RE: ADDENDUM #5 TO THE COMSTOCK MINING INC., CARSON RIVER MERCURY SUPERFUND SITE SAMPLING AND ANALYSIS PLAN

On behalf of Comstock Mining Inc. (Comstock), McGinley and Associates (MGA) are providing this revised Addendum #5 for the Gold Creek Canyon area.

Gold Creek Canyon/Hartford Proposed Sampling

**Justice Pit Area
Proposed Sampling**

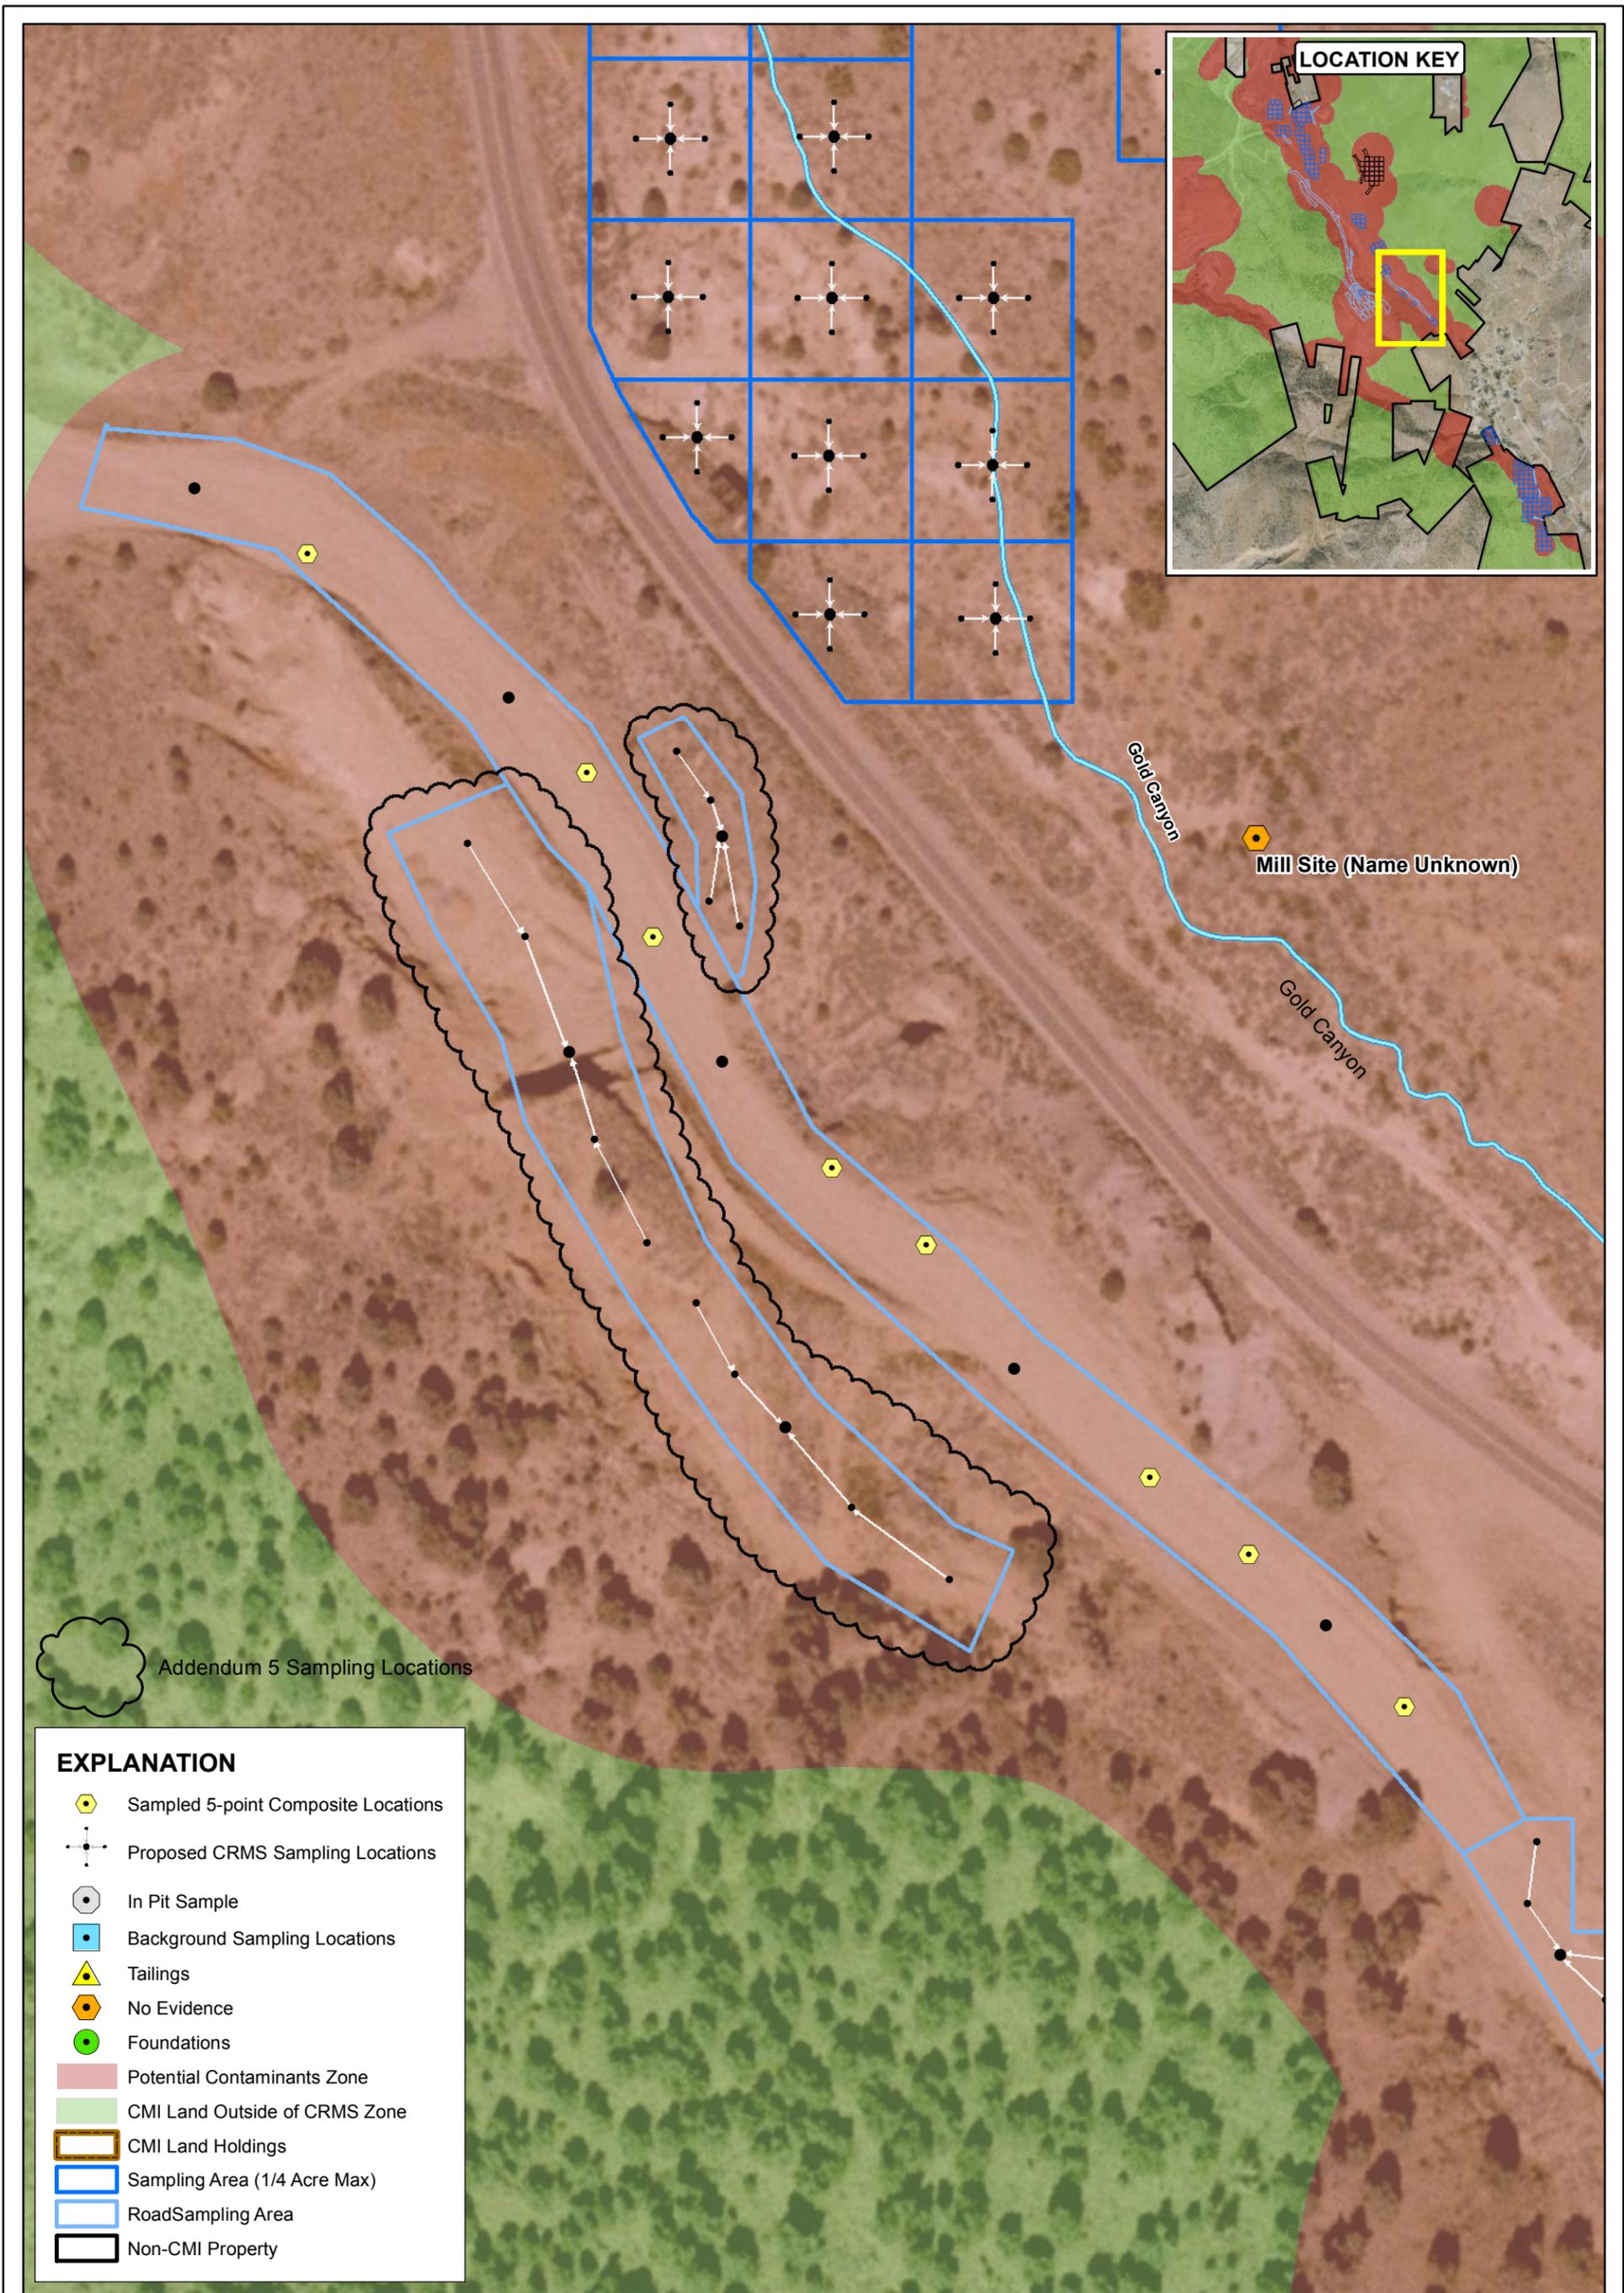
In addition, as a service to the community, Comstock proposes to collect samples at locations in and around areas which were believed to be former mill sites. Comstock's archaeological survey indicated no evidence of any historic activities, however, to be conservative, Comstock proposes to collect samples at and around these locations as detailed below under Action Items and on Figure 1.

1. Gold Creek Canyon Area, Comstock proposes to collect samples at the locations shown on the attached Figure 1.
 - a. Consistent with the SAP, these samples will be 5-point composite samples and will be collected from 0-2' below ground surface (bgs) in six inch increments. These are shown on Figure 1 with the symbol "Proposed CRMS Sampling Locations (5-Point Composite)"

- b. Based upon Comstock's understanding of the region, it is expected that the depth of the materials in these areas, if present, will be 10' or less. To address these potential fill materials Comstock has added 12 sampling locations as shown on Figure 1 with the symbol "Single Point Sample Location". These locations will be installed to the full depth of fill materials.

- i. Consistent with the SAP Section 4, Item 2.d., Comstock will treat these materials in a manner similar to suspected tailings. Specifically, per the SAP:

1. Tailings piles will be sampled from 0-6" bgs.
 2. Additional samples will be collected at the 2' bgs interval and every 2' thereafter for tailings piles up to 10' in depth.

3. Additional samples will be collected at the 4' bgs interval and every 4' thereafter for tailings piles 10' - 20' in depth.
 4. For tailings piles greater than 20' in depth samples will be collected at 0-6" bgs, at the 10' bgs depth interval and every 10' thereafter.
